Title - Sujet Wharf Reconstruction 403,404-SM-SR	
Solicitation No. - N° de l'invitation EC015-161626/A	Amendment No. - N° modif. 002
Client Reference No. - N° de référence du client R.076598.001	Date 2016-03-04
GETS Reference No. - N° de référence de SEAG PW-\$PWB-020-3824	
File No. - N° de dossier PWB-5-38200 (020)	CCC No./N° CCC - FMS No./N° VME
Solicitation Closes - L'invitation prend fin at - à 02:00 PM on - le 2016-03-09	Time Zone Fuseau horaire Atlantic Standard Time AST
F.O.B. - F.A.B. Plant-Usine: <input type="checkbox"/> Destination: <input checked="" type="checkbox"/> Other-Autre: <input type="checkbox"/>	
Address Enquiries to: - Adresser toutes questions à: Donovan, Janine PWB	Buyer Id - Id de l'acheteur pwb020
Telephone No. - N° de téléphone (506) 636-5347 ()	FAX No. - N° de FAX (506) 636-4376
Destination - of Goods, Services, and Construction: Destination - des biens, services et construction:

This Solicitation Amendment No. Two (2) is raised to include the following addendum no. 2.

Addendum 2.

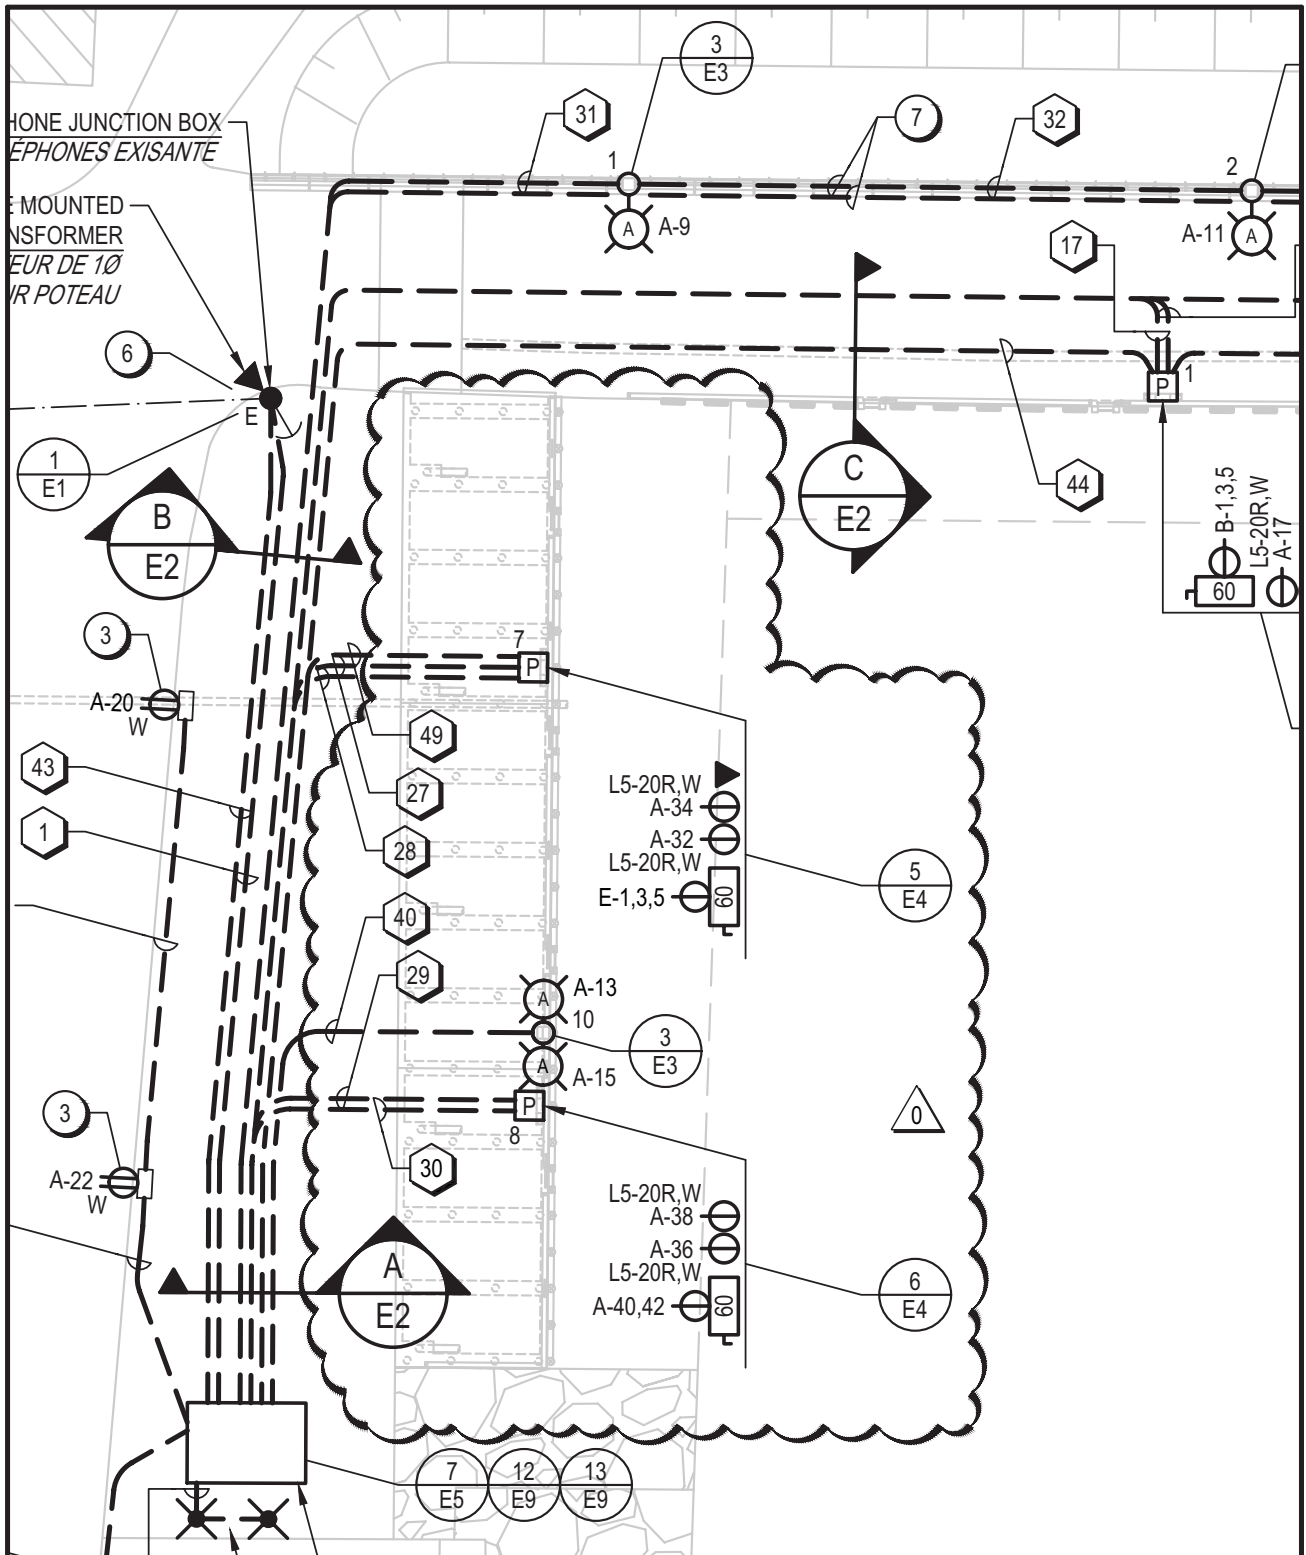
1. Reference drawing E1- Wharf Plan Electrical.

1. Marginal wharf indicated as future will now be installed before work begins on the existing wharf structure. Service modules 7 and 8 indicated as future in notes 1 and 2 to be installed and wired as per sketch ESK-E1 and details.
2. An additional light pole with two type A luminaires is to be installed on the marginal wharf. Pole to have tenon adaptor for mounting two luminaires at 180 degrees. Install conduit and wiring as indicated on ESK-E1.
3. Conduits for marginal wharf service modules and lighting to be sloped up from trench and run in the marginal wharf concrete deck. Install additional concrete encasement from deck to trench.
